Docket No. 50-336  
A01155

Millstone Nuclear Power Station, Unit No. 2  
Additional Information on Cycle 4 Reload

Additional Information on Cycle 4 Reload

FIGURE 4.2-1 - AUGMENTATION FACTORS VS. DISTANCE FROM BOTTOM OF CORE

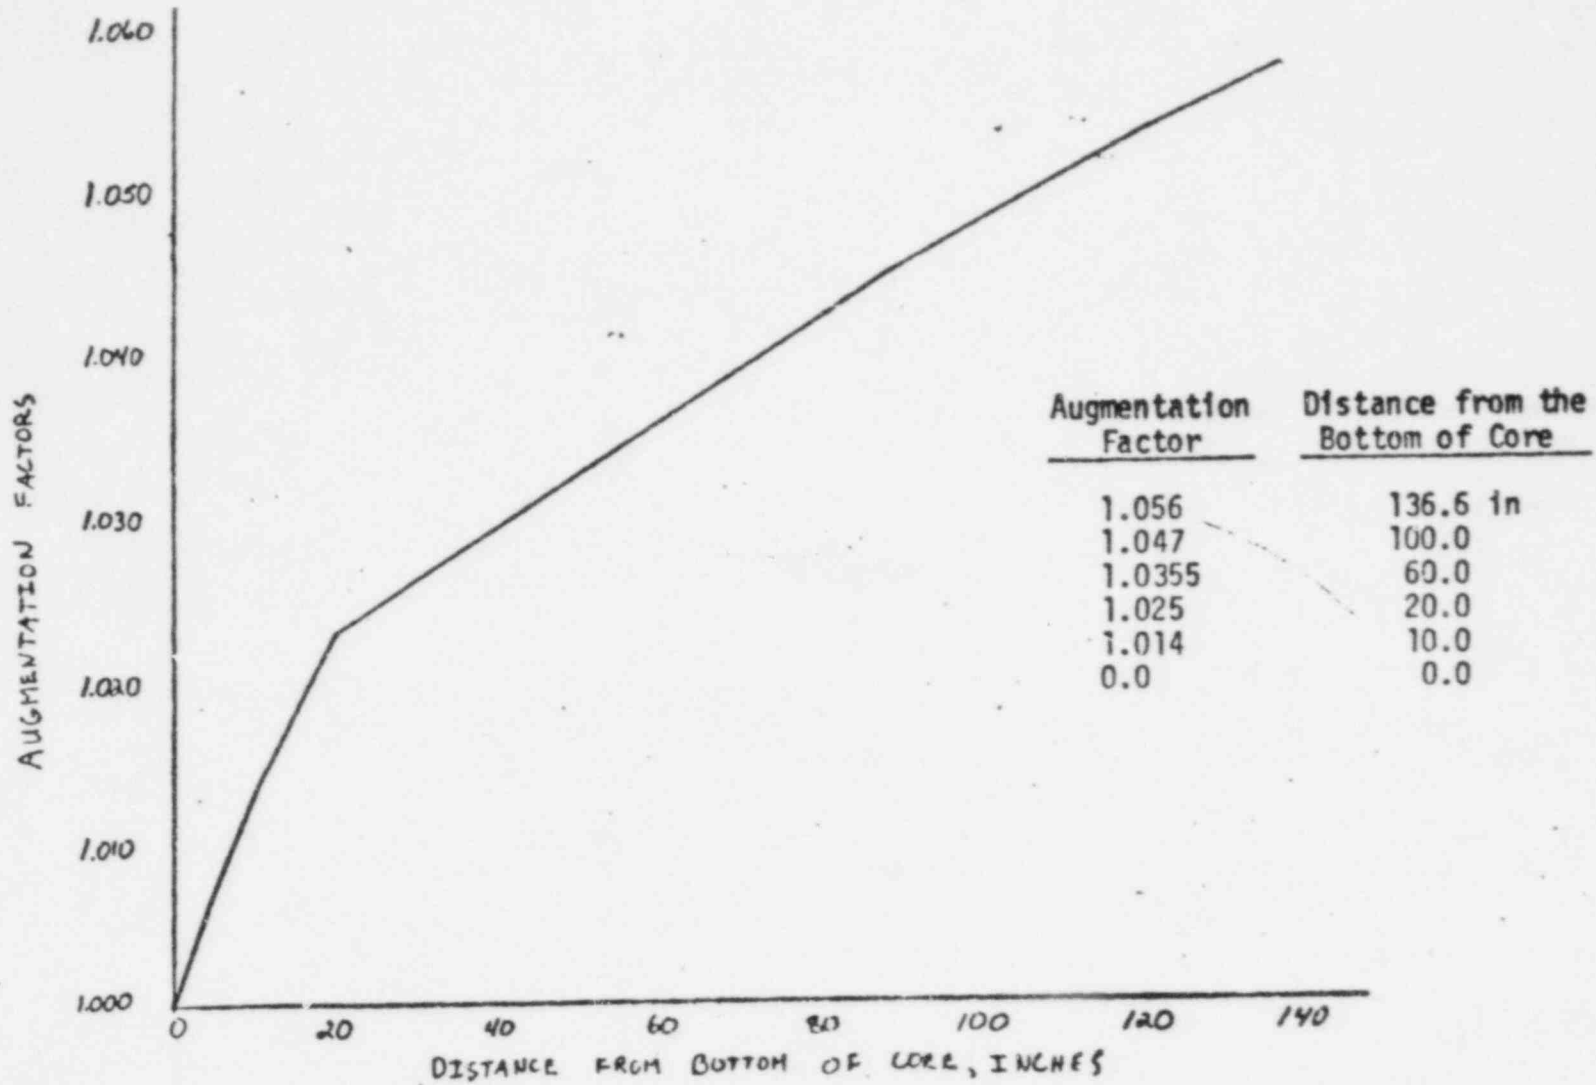
2. Previous cycles have used an augmentation factor to account for the power density spikes due to axial gaps caused by fuel densification. These previous cycle augmentation factors were included in the determination of  $F_{xy}$ . How are densification spikes accounted for in Cycle 4?

Power peaking augmentation factors shown in attached Figure 4.2-1 will be used for Cycle 4. They were included in the determination of  $F_0$  for all accident analyses performed for Cycle 4. The Technical Specification limits on local power density (Figure 2.2-2), LOCA peak linear heat rate (Figure 3.2-1), and LOCA allowable power level (Figure 3.2-2) also account for the augmentation factors.
